ADDENDUM #1

Contract Documents Entitled State Technical College of Missouri (1H3) Airport Fence Replacement Project
MoDOT Project #24-044A-1

Designer of Record: WSP USA, Inc.

Addendum #1 is herewith made a part of the Contract Documents of the above issued project, and is issued to amend and supplement the January 2025 drawings and specifications as follows:

FENCE REPLACEMENT
SITE PLAN
SHEET 2 OF 2

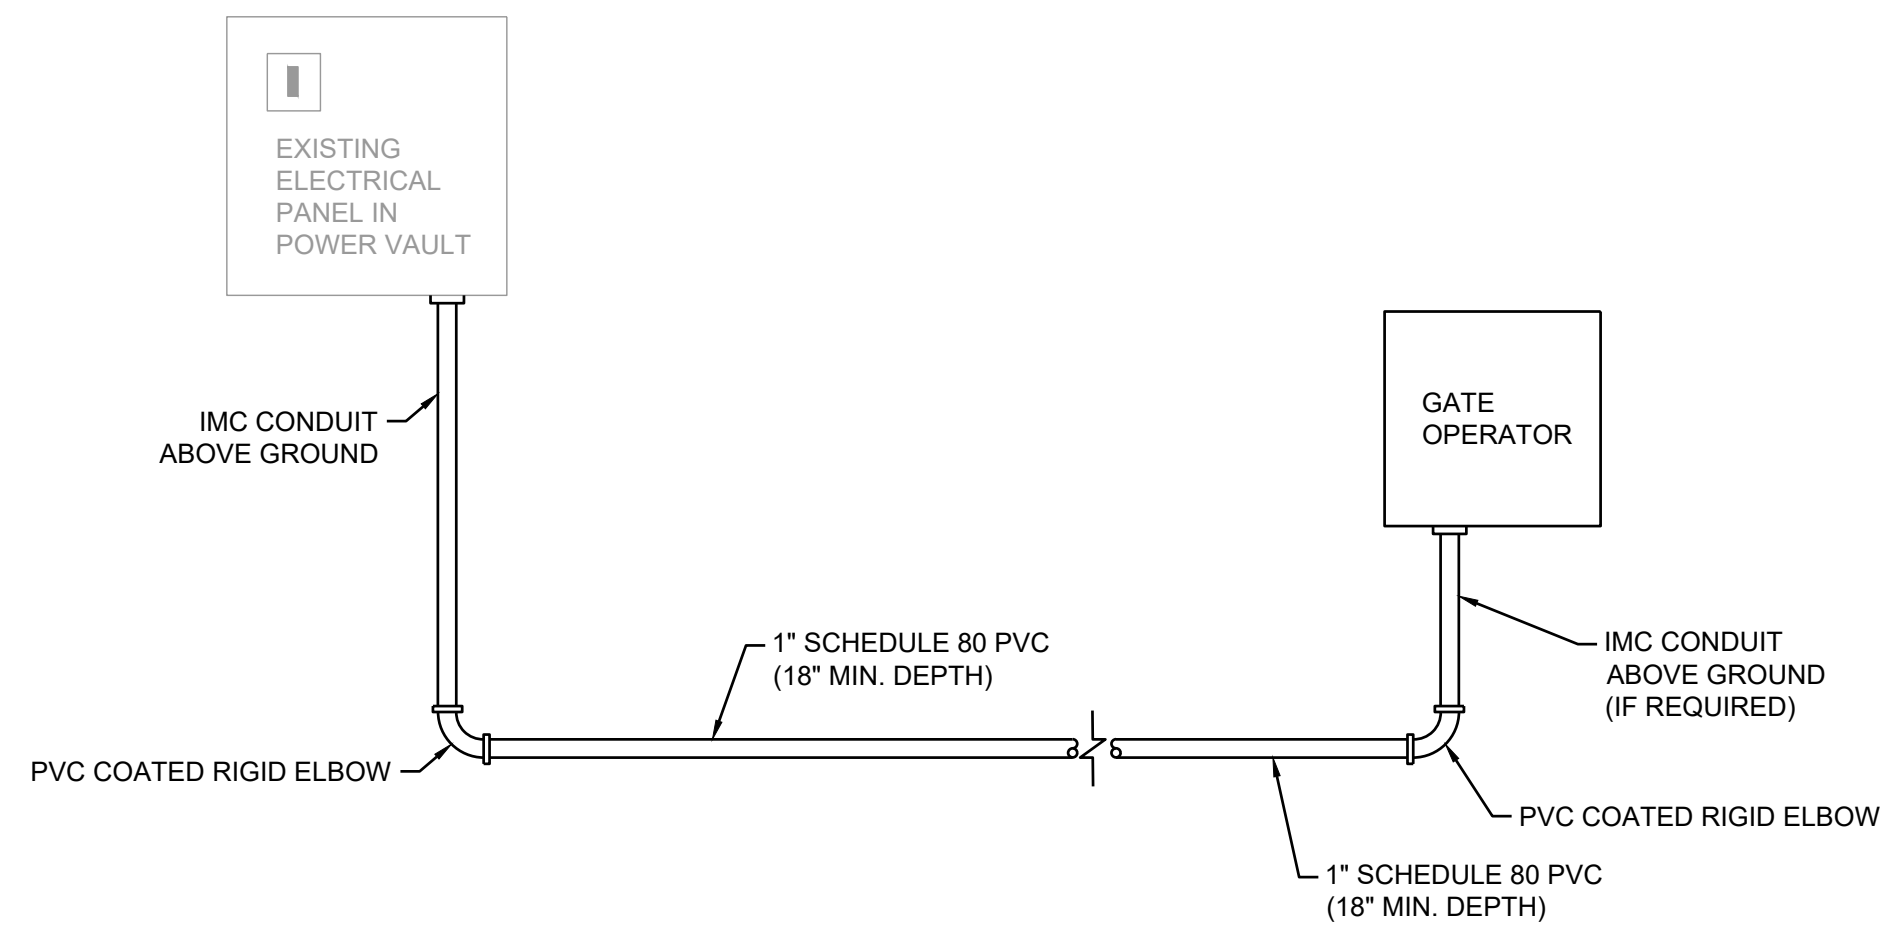
- △ 10. CONTRACTOR TO PROVIDE KEYPAD ACCESS CONTROL AS SHOWN ON FOLLOWING SHEET AS SUBSIDIARY TO BID ITEM F-162-5.5 "25FT AUTOMATIC SLIDE GATE".
11. QUANTITIES PROVIDED ON THIS SHEET ARE FOR CONTRACTOR INFORMATION ONLY AND SUBSIDIARY TO BID ITEM F-162-5.5 "25FT AUTOMATIC SLIDE GATE".

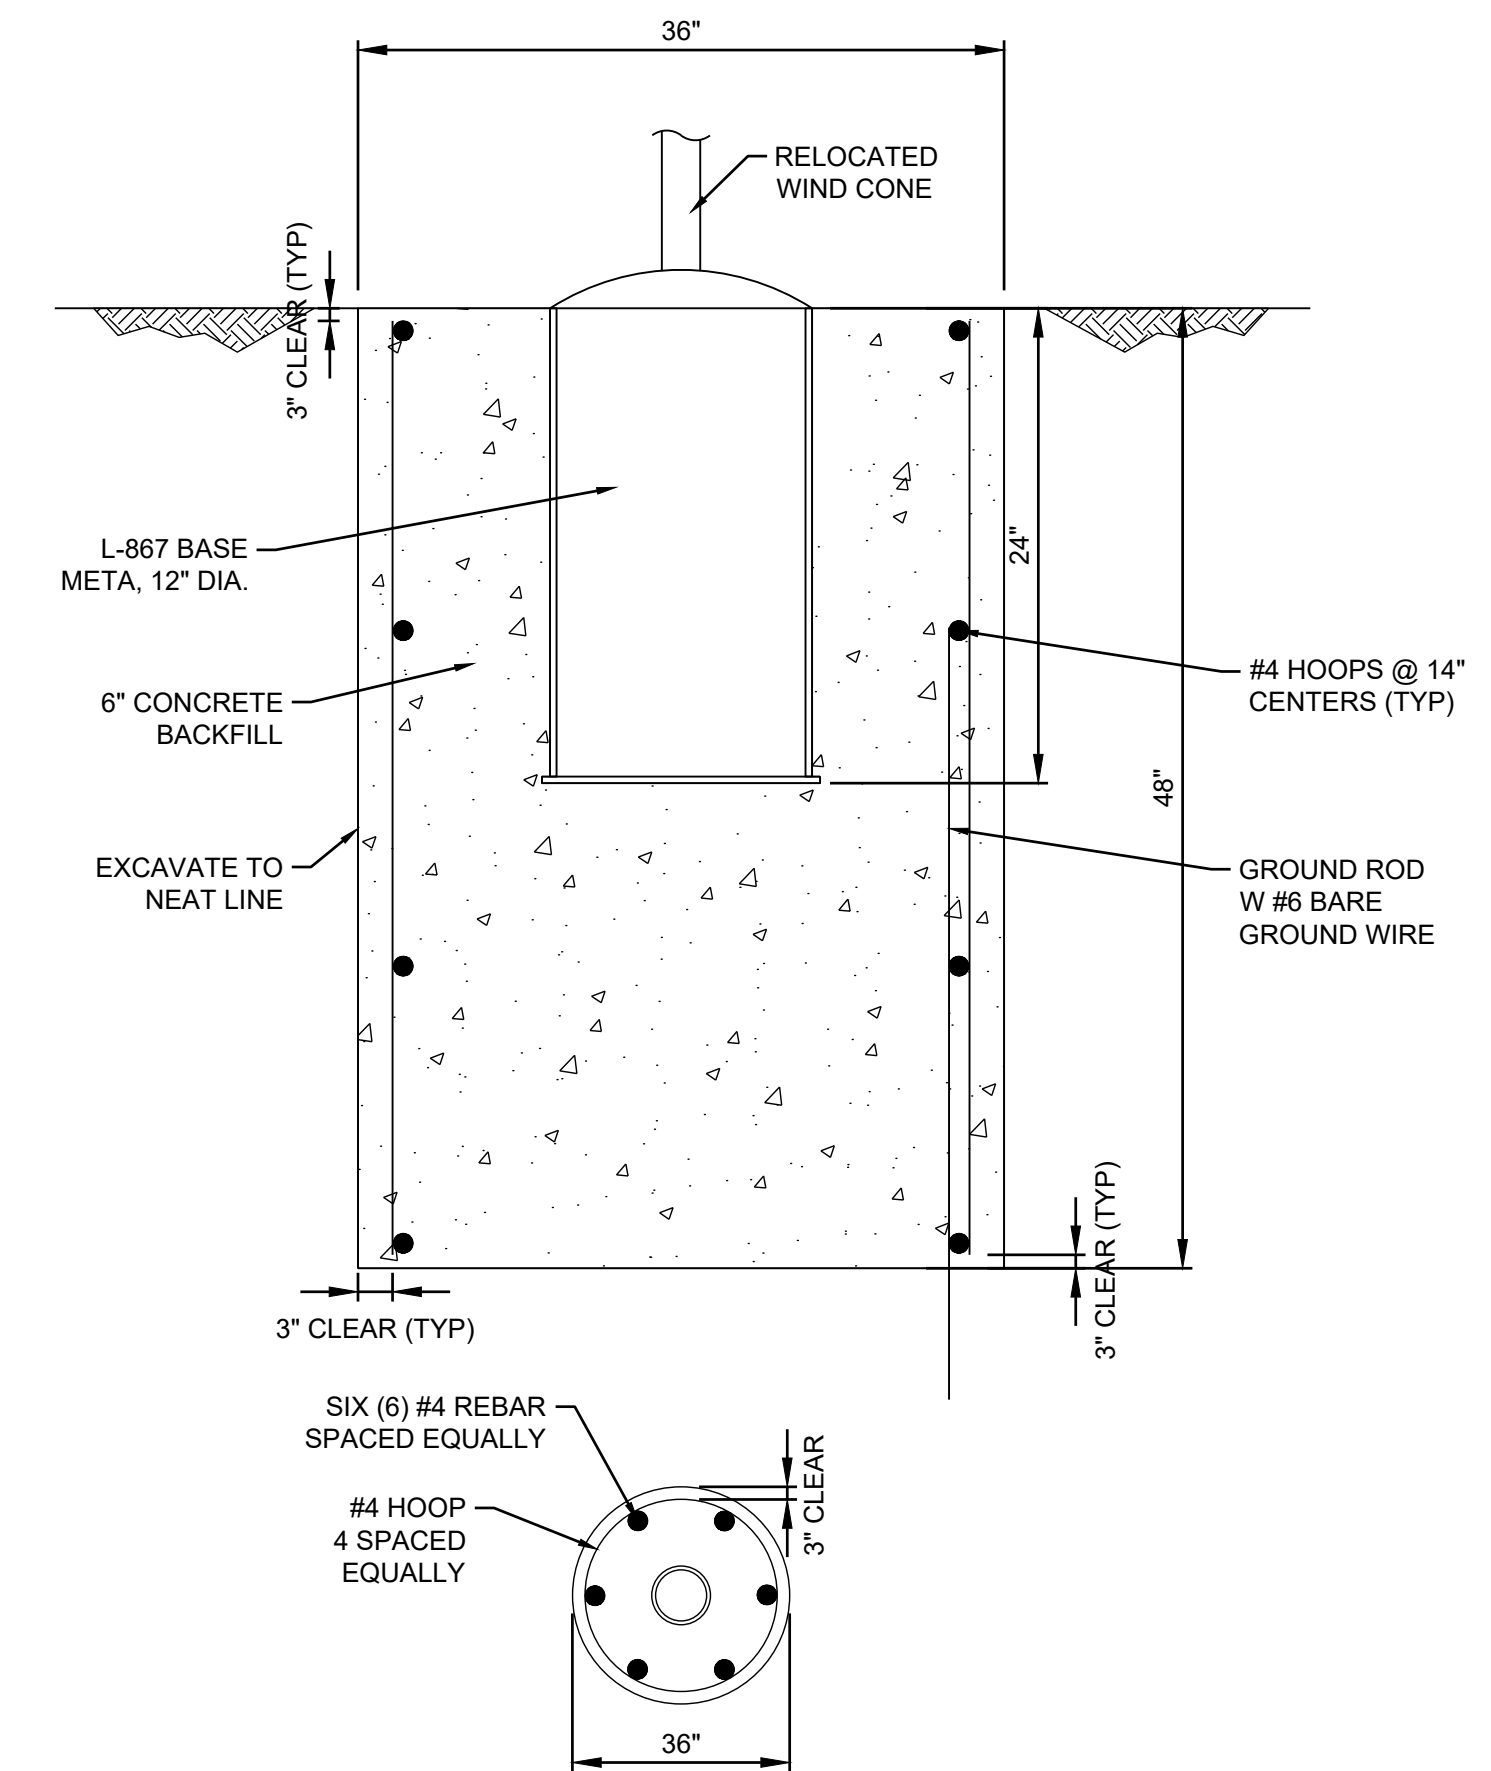
- FURNISH AND INSTALL INFRARED PHOTO CELL FOR EXTERNAL ENTRAPMENT PROTECTION DEVICE. PROVIDE TWO PHOTOEYE SYSTEMS PER GATE OPERATOR FOR PROTECTION IN THE OPEN AND CLOSE DIRECTION.
